**CONTAINMENT LINER TEST CHANNEL
AT
BEAVER VALLEY POWER STATION - UNIT NO. 1**

MARCH 1, 1979

**PREPARED BY
STONE & WEBSTER ENGINEERING CORPORATION
for
DUQUESNE LIGHT COMPANY**

**FIG. 1 SHEET 1 OF 2
DETAILS OF MATERIALS
LINER AND TEST CHANNELS**

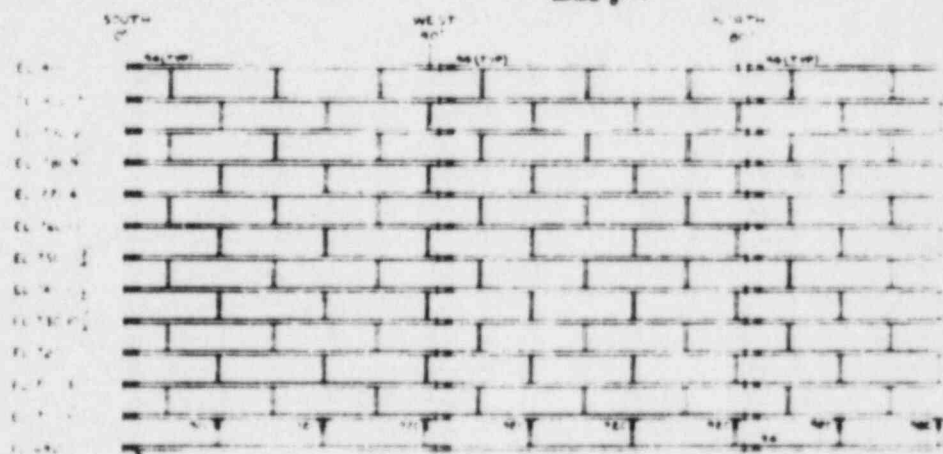
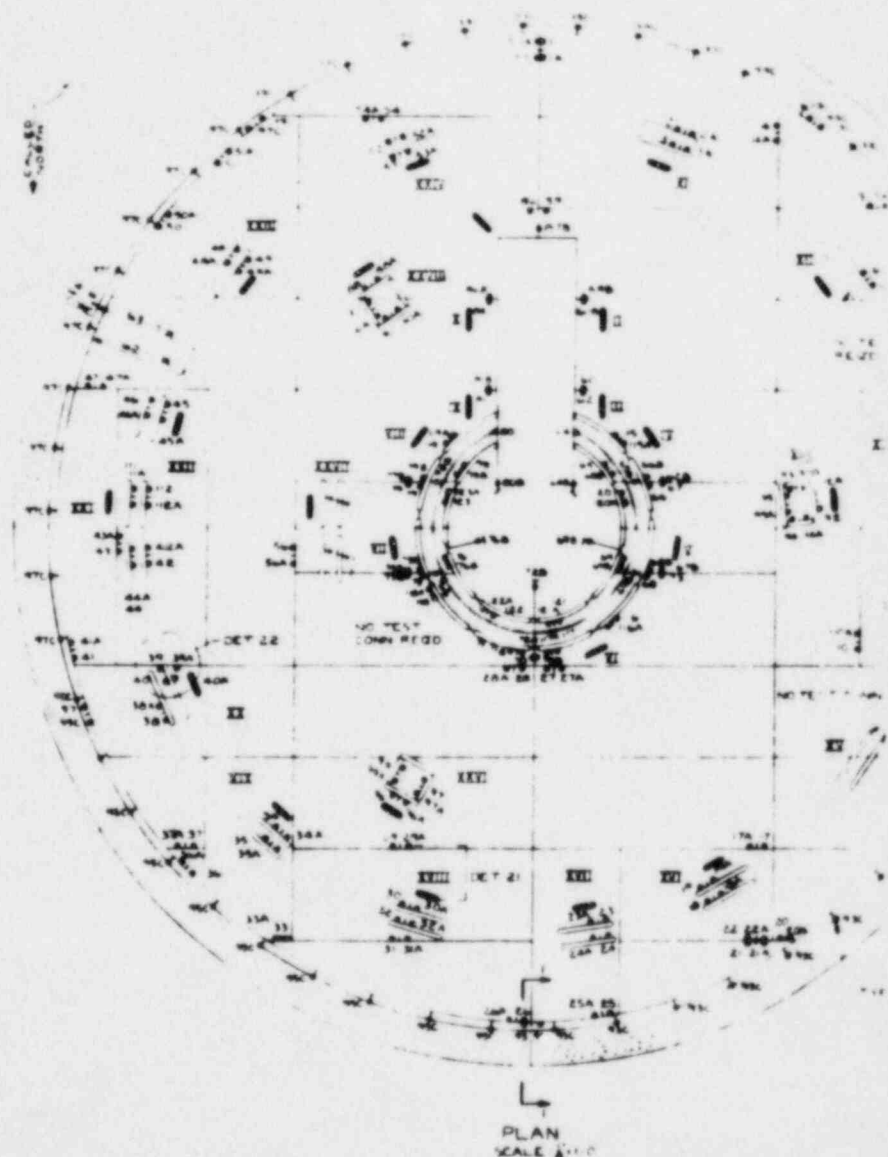
A.1 Materials Identification and Construction Procedures

Provide the details of the materials used and procedures for construction for all wall boxes and specify by elevation or location, where differences occur. Provide procedure 205 used in the welding of horizontal and vertical test channels. Provide the procedures for welding the test connection to the channel boxes and the procedures for tightening (torquing) the plugs.

A.1 The details of the materials used in the construction of the containment liner and test channel boxes are listed on Figure 1, 2 sheets, attached. The liner plate materials and the test channel material were purchased with extensive mill documentation, chemicals and physicals, to assure the level of quality required for fabrication and design service.

The material used for the liner is ASTM A537 Gr. B from the bottom up to El. 720 ft-11 in on the shell. Above that elevation and including the dome, the material is ASTM A516 Gr. 60.

Refer to Figure 1(b) for a comparison of the mechanical and chemical properties of the liner plate and test channel materials.

FIGURE 2(a)
LINER BOTTOM - TEST
CHANNEL ARRANGEMENT
CONTAINMENT
BEAVER VALLEY POWER STATION - UNIT No. 1
DUQUESNE LIGHT COMPANY

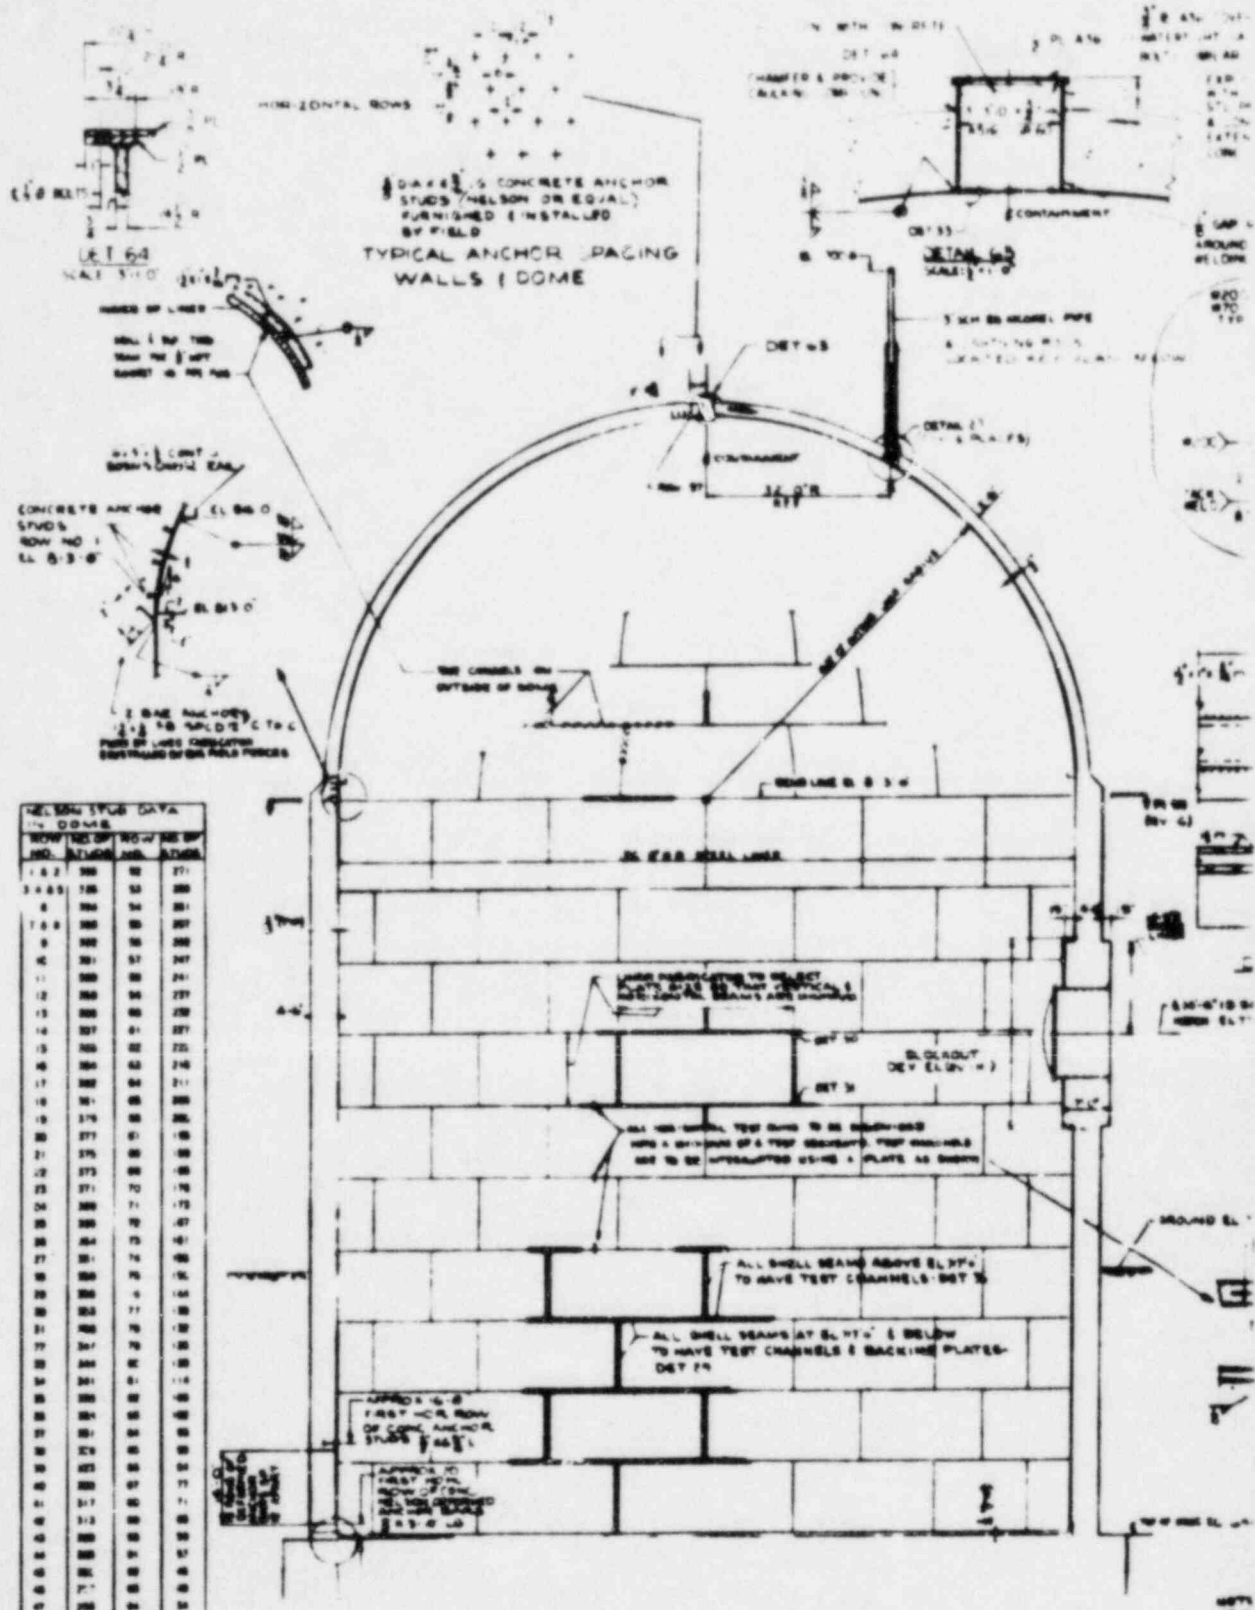
NOTE: In all of the above where procedures are requested but may not exist, describe the information or process in sufficient detail to permit NRC evaluation.

C.1 Plugs are installed in test channel test port panels to prevent seepage into the channels. These clusters of test connections are located in regions of the mat away from low spots inside containment and consequently would not trap water. Figure 2a locates the various test panels in the floor.

FIG. 3(c)
TEST CHANNELS-DOME DETAILS

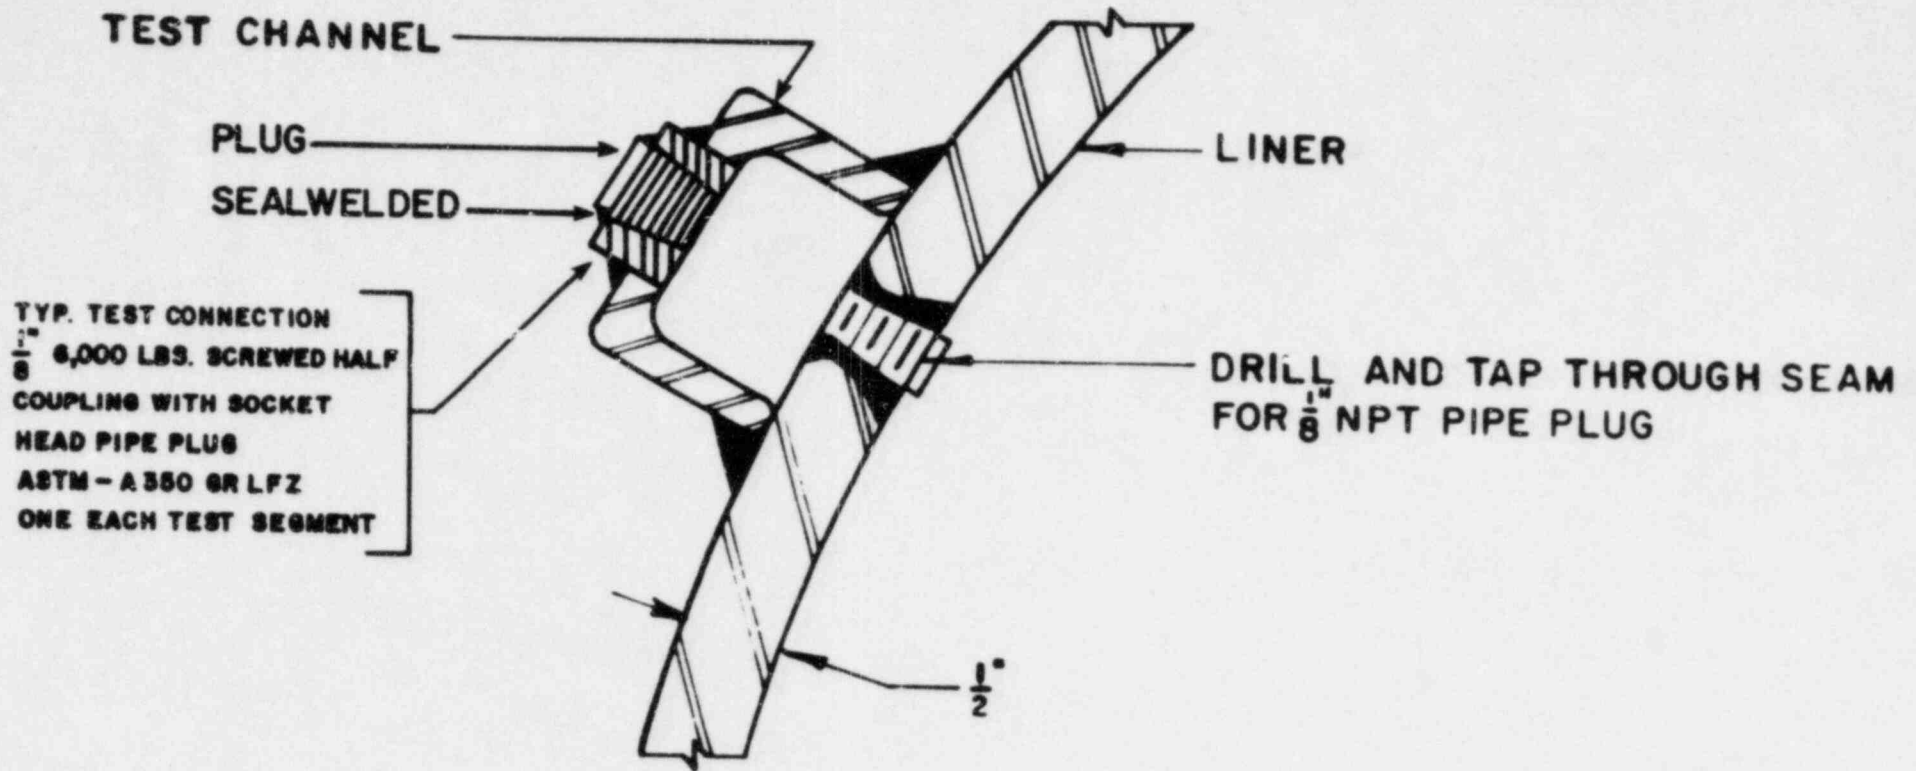
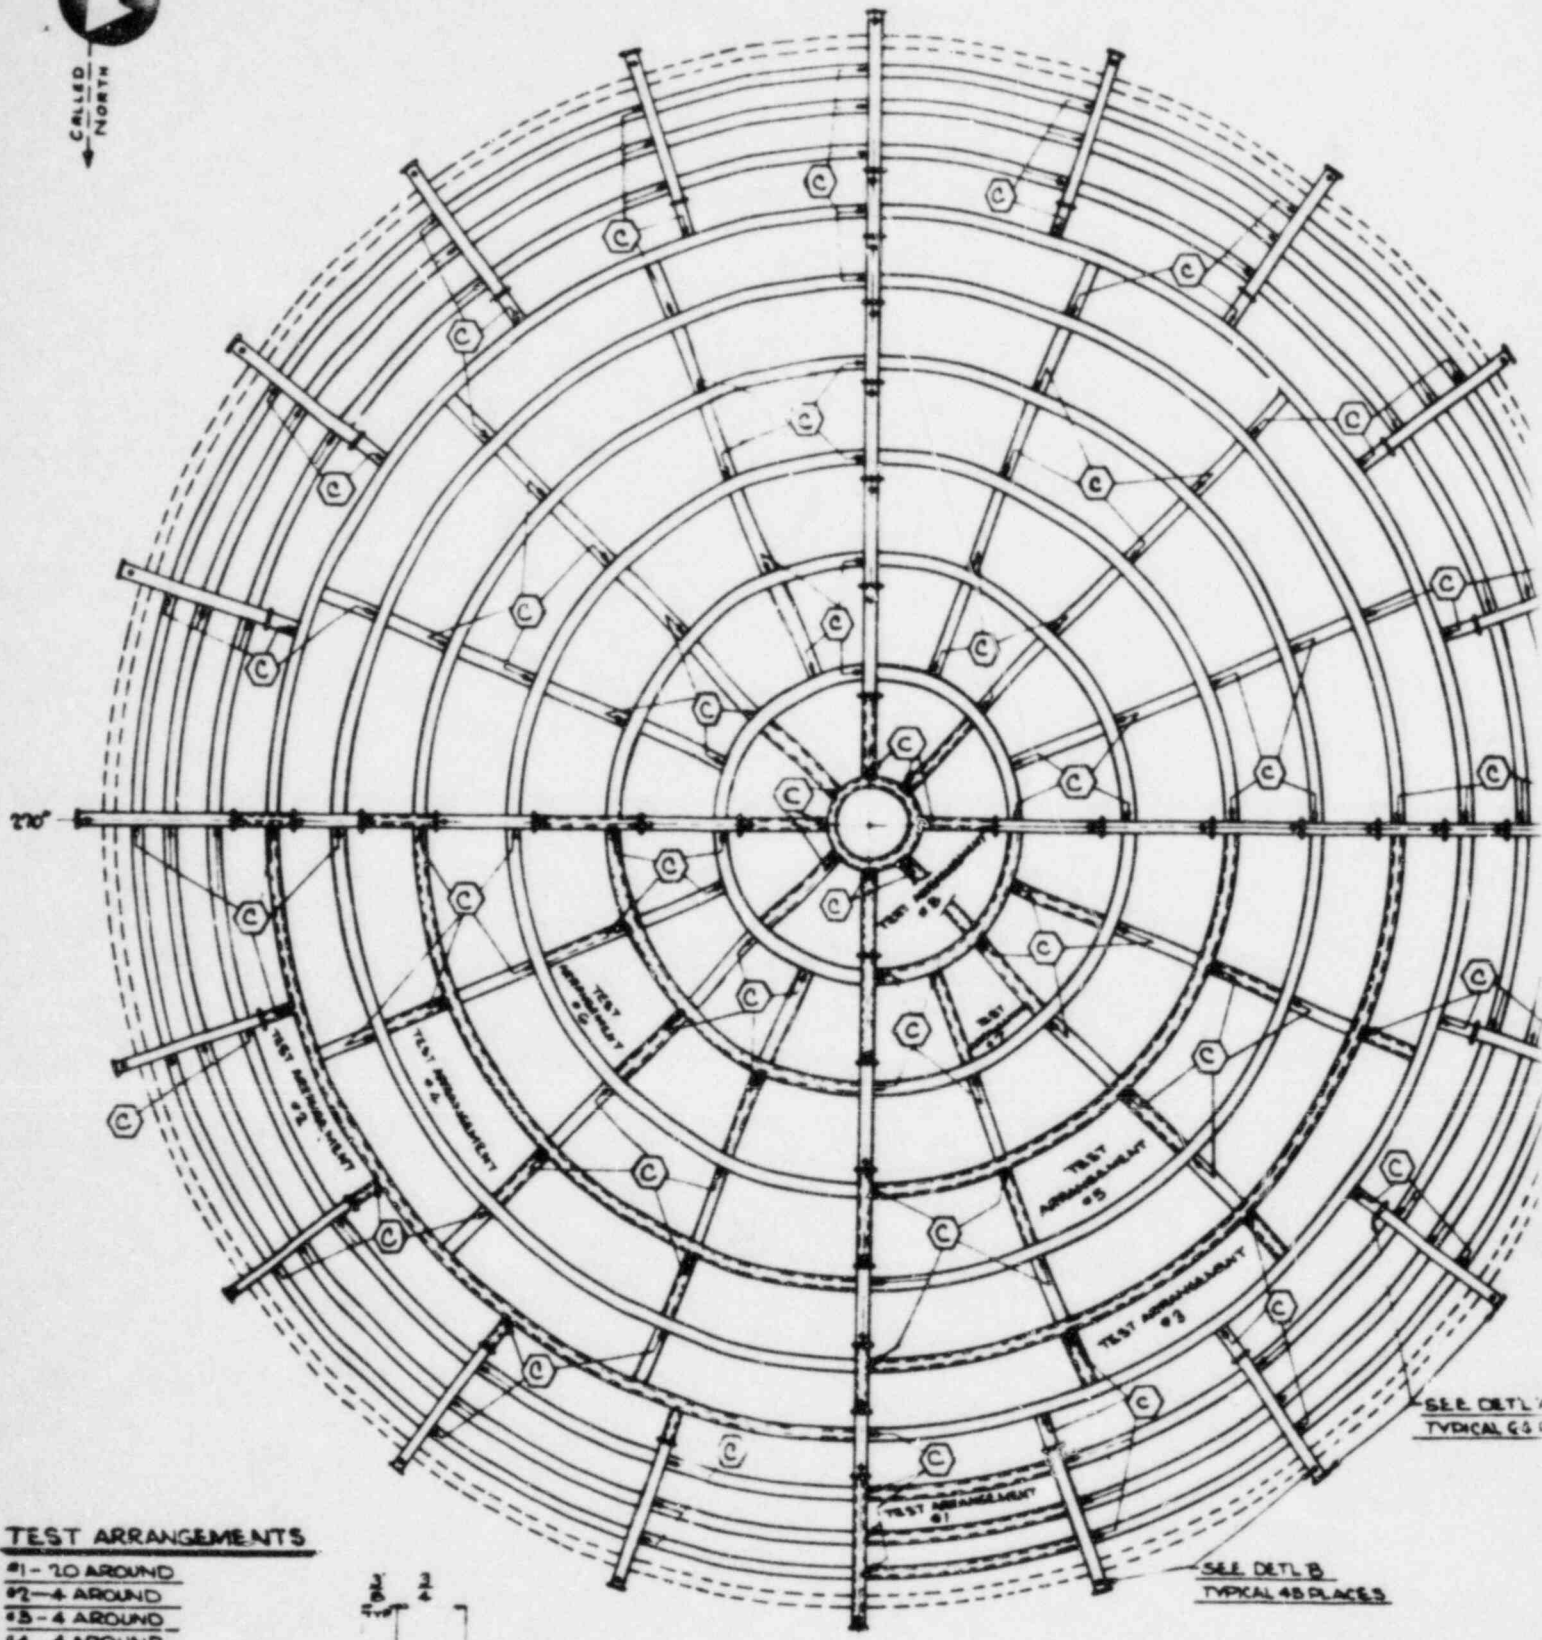
B.1 Materials Identification and Construction
Description

Provide as-built descriptions and drawings of the dome channel details specifically the plug assembly in the liner seam welds. Provide construction assembly procedures and address the immediate surroundings of the channel boxes on the exterior of the liner. Provide the basis for assuring these channel welds will hold against the shear forces if the liner moves against the concrete structure.

B.1 Figures 3c, 4 and 6 illustrate the details of the dome test channels.

FIGURE 5 CONTAINMENT LINER-STRAIN CURVES

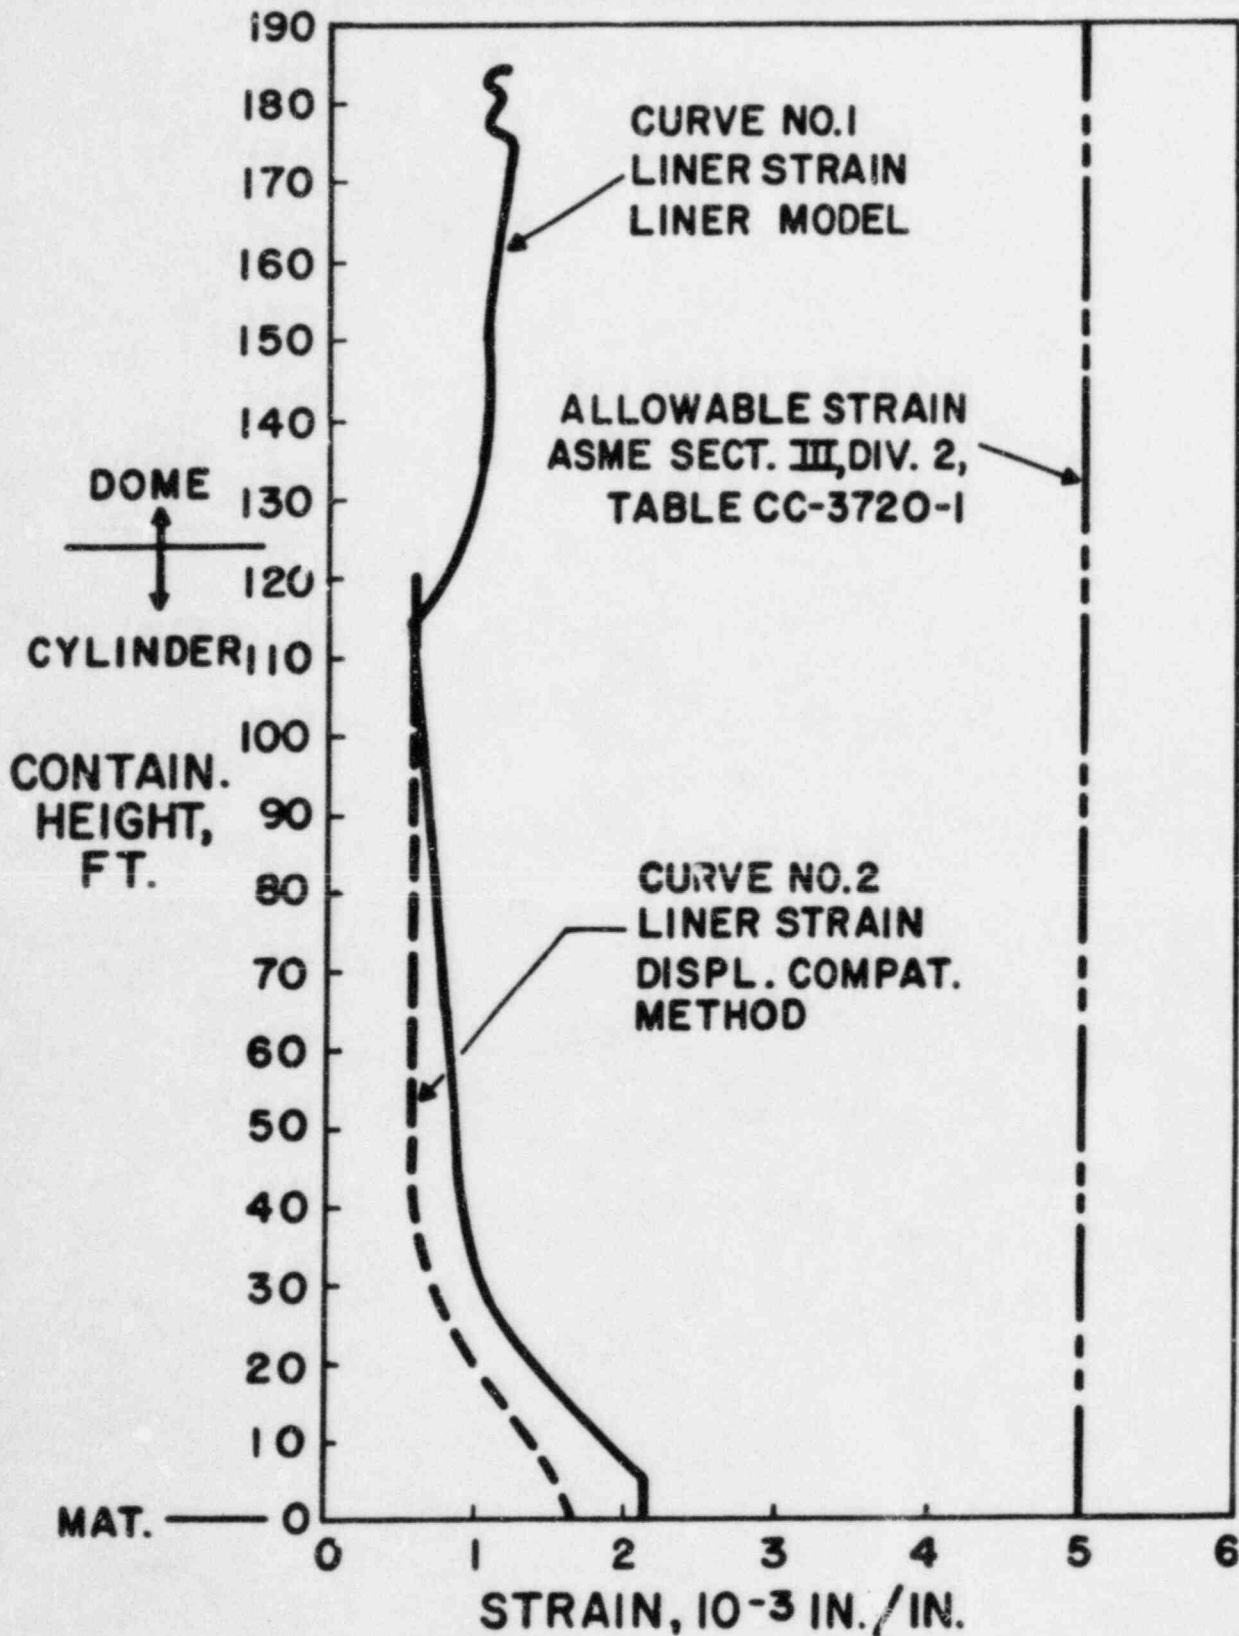
A.3. Structural Integrity of Channel Boxes (For Maintaining Leak Tightness)

Provide an analysis which would demonstrate that the channels and channel welds will be capable of carrying the differential movement or expansion of the liner. Consider liner buckling or bulging due to Loss-of-Coolant Accident (LOCA) temperature and dynamic pressure effects and seismic loads. Provide a comparative analysis to demonstrate leak channels and their welds meet the requirements of the ASME Boiler and Pressure Vessel Code Section 3, Div. 2, as appropriate.

The current industry code applicable to the design of containment liners is ASME Section III, Division 2. This code recognizes that liner forces are displacement limited and provides liner allowables in inch/inch of strain. In order to compare stress results with current code strain limits, the membrane and bending stresses calculated by elastic theory have been converted to strain (by dividing stresses by the Modulus of Elasticity) and are plotted in Figure 5, Curve No. 1. Since these strains are mostly membrane strain, they are conservatively compared in the figure to the lower code allowable for membrane strain of 5×10^{-3} in/in. (The code allowable for membrane plus bending is 14×10^{-3} in/in.)

The above approach was checked by consideration of displacement compatibility between the liner and the reinforced concrete wall using the resulting displacements from the analysis of the reinforced concrete structure. This results in lower liner strains as indicated by Curve No. 2 in Figure 5.

made by assuming that the strain in the TC is the same as that of the liner to which it is attached. (This is conservative since the liner strains are very conservatively calculated.) As indicated in Figure No. 5, liner strains (and, therefore, TC strains) are well below the ASME allowable membrane strain of 5×10^{-3} in./in. Calculations indicate that the liner has a factor of safety of 1.8 against buckling based on the very conservative liner stress calculation. The local presence of test channels tends to stiffen the liner, thereby further reducing any potential for buckling. Since bending stresses are small, the TC attachment welds are subjected primarily to the same membrane strains as the liner and would have the same margin against the 5×10^{-3} in./in. code strain allowable.
